Subject: Duke Energy Carolinas, LLC
Oconee Nuclear Site, Units 1, 2, and 3
Docket Numbers 50-269, 50-270, and 50-287
Request for Additional Information associated with the License Amendment
Request (LAR) for Approval to Mitigate Alloy 600 Concerns in the
Oconee Pressurizer
LAR No. 2008-08

REQUESTS FOR ADDITIONAL INFORMATION

OM 2201-3212.001, Rev D01 - ONS3 1.5" Pressurizer Thermowell Repair Design

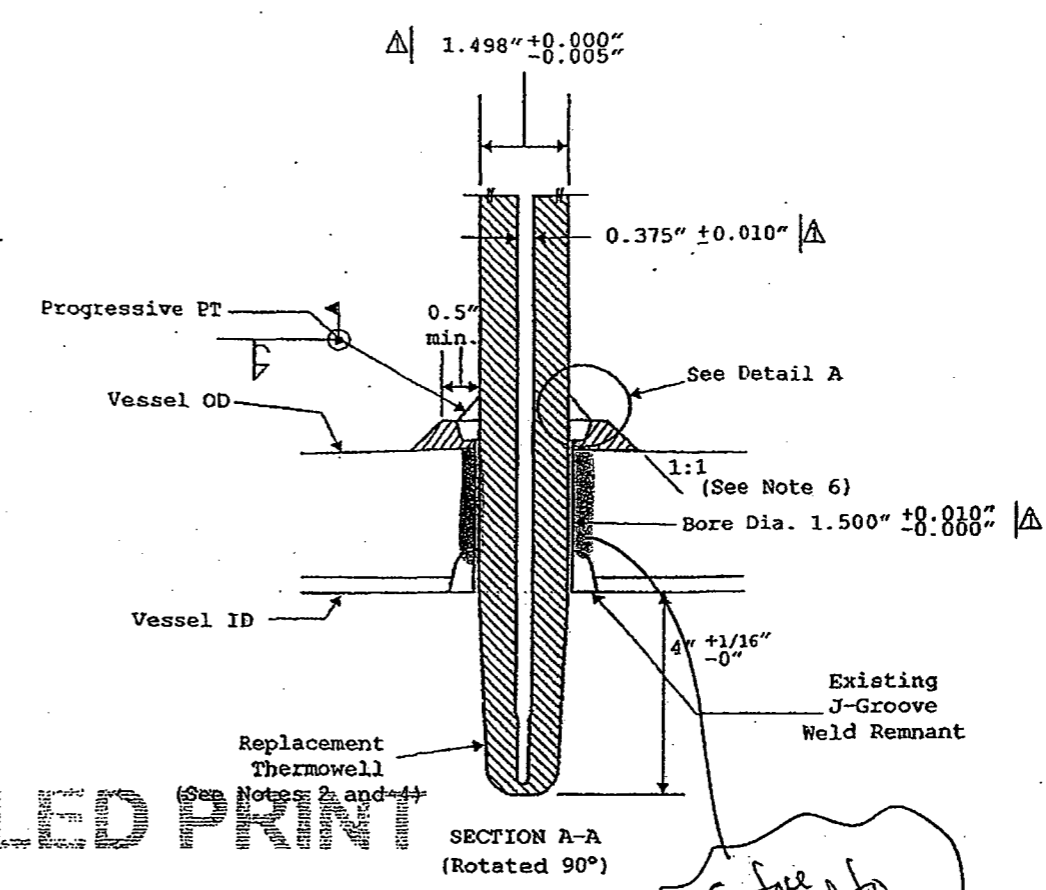
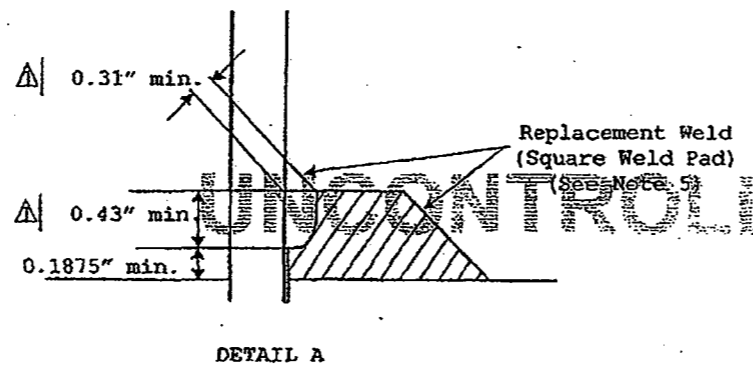
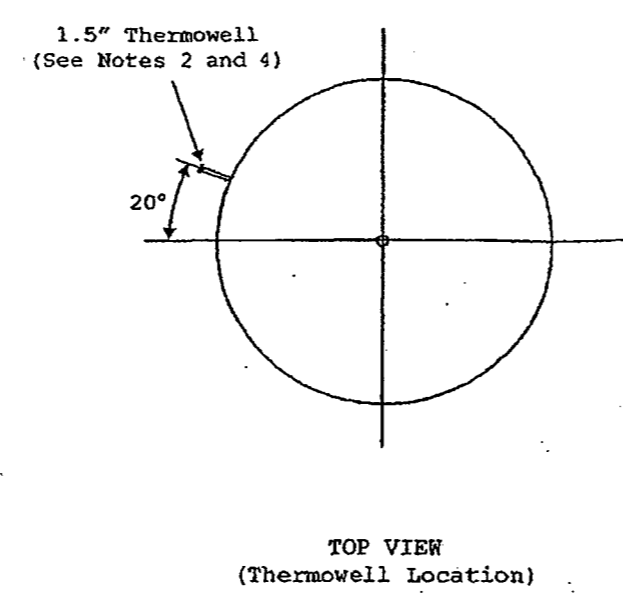
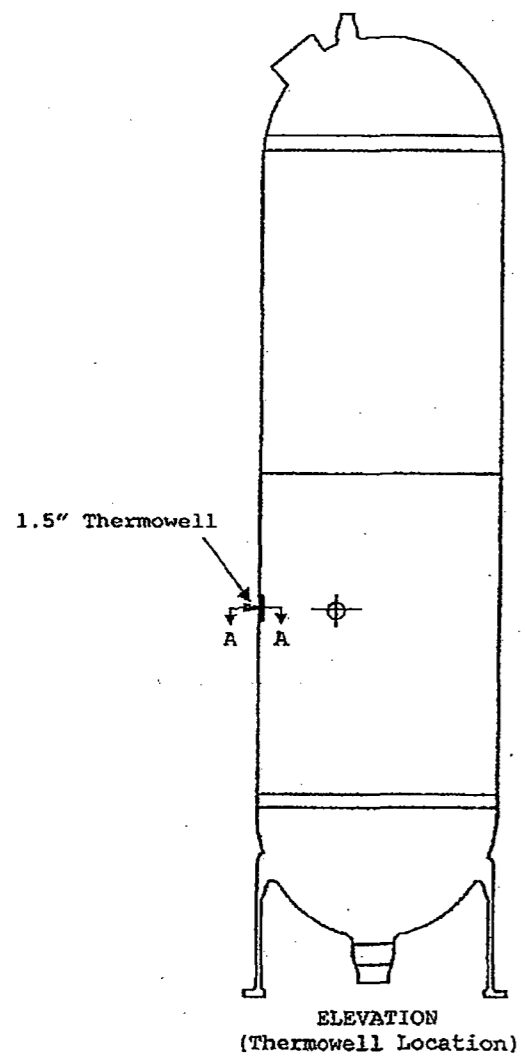
Please provide marked-up drawings of the Pressurizers showing the exposed areas of the material that is subject to corrosion.

As noted in the original LAR package, these repairs have already been completed on two units and are scheduled for implementation on Unit 2 in the fall of 2008. The drawings provided in Attachments 1, 2, and 3 are representative of the repairs on all three units. Attachments 1, 2, and 3 contain the mark-ups requested. Attachments 1 and 2, included in the original LAR, are provided in a larger format. Attachment 3 shows the physical location of the repairs in the Unit 2 pressurizer. These locations are representative for all three units.

Surface Exposed to Corrosion
